Office Action Summary

10/817,184

2. Claims 9-16 are rejected under 35 U.S.C. 103(a) as being unpatentable over Olisar et al. (USP 4,873,456) in view of a Japanese reference JP 5-37305.

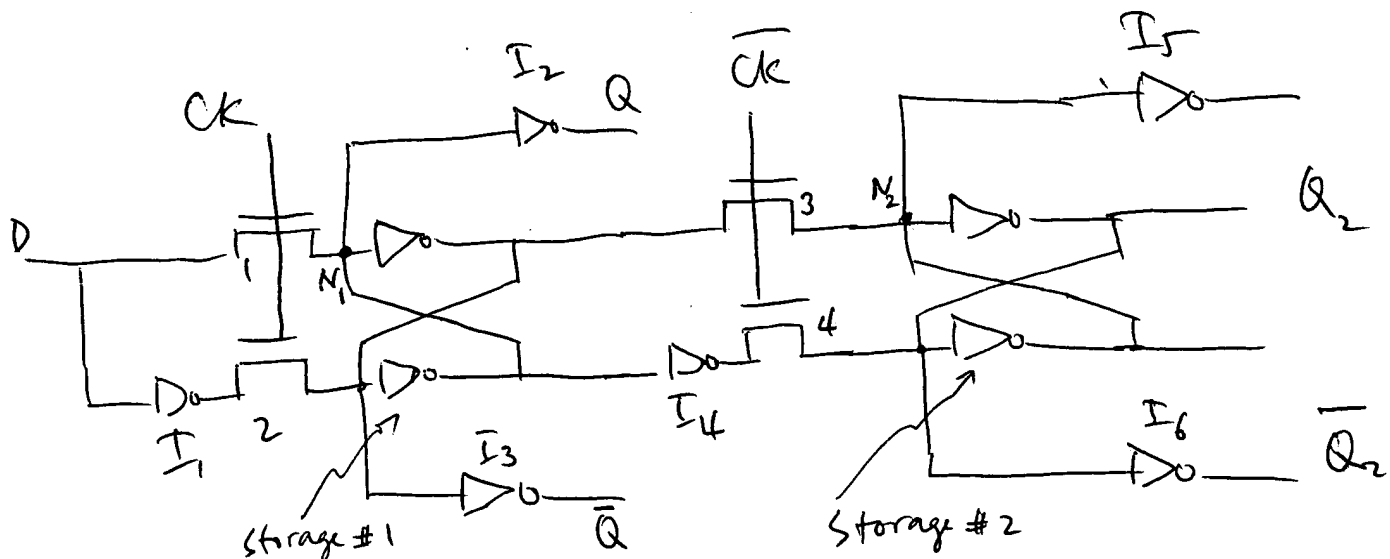
Below is the detailed arrangement of the combination of Olisar et al. and JP 5-37305 references. The combination of reference comprises an input signal (D), a first pass gate (1), a first storage node (N1), a second pass gate (3), a first inverter (I4), a third pass gate (4), an unclocked second storage node (N2) as called for in claim 9.

Regarding claim 10, the combination of references shows a second inverter (I5) and a third inverter (I6).

Regarding claim 11, the combination of references shows the first storage node comprises two inverters.

Regarding claims 13, the combination of references shows the second storage node comprises two inverters.

Regarding claim 12, the combination of references shows fourth and fifth inverters (upper and lower inverters of the storage nodes) but does not disclose the sixth inverter is weaker than the fourth inverter. However, it is known to have the upper inverter of the master stage bigger than the upper inverter of the slave stage in order to overcome the signal of the subsequent stage (slave stage) thus preventing erroneous operation. Therefore, outside of an non-obvious results, the obviousness of having inverters of different size will not be patentable under 35USC 103(a).

Regarding claim 14, the combination of references shows does not disclose the fourth inverter (upper inverter of the second storage node) is weaker than the first inverter (I4).

However, it is known to have the input inverter bigger than the inverters of the storage within the master or slave flip flop in order to overcome the signal within the latch thus preventing erroneous operation. Therefore, outside of an non-obvious results, the obviousness of having inverters of different size will not be patentable under 35USC 103(a).

Regarding claims 15-16, since the first and second storages are not clocked storage, therefore, the stored input data and the inverted stored input data conveyed to the true and complement output nodes (Q2, Q2/) regardless of states of the master clock signal and the slave clock signal.
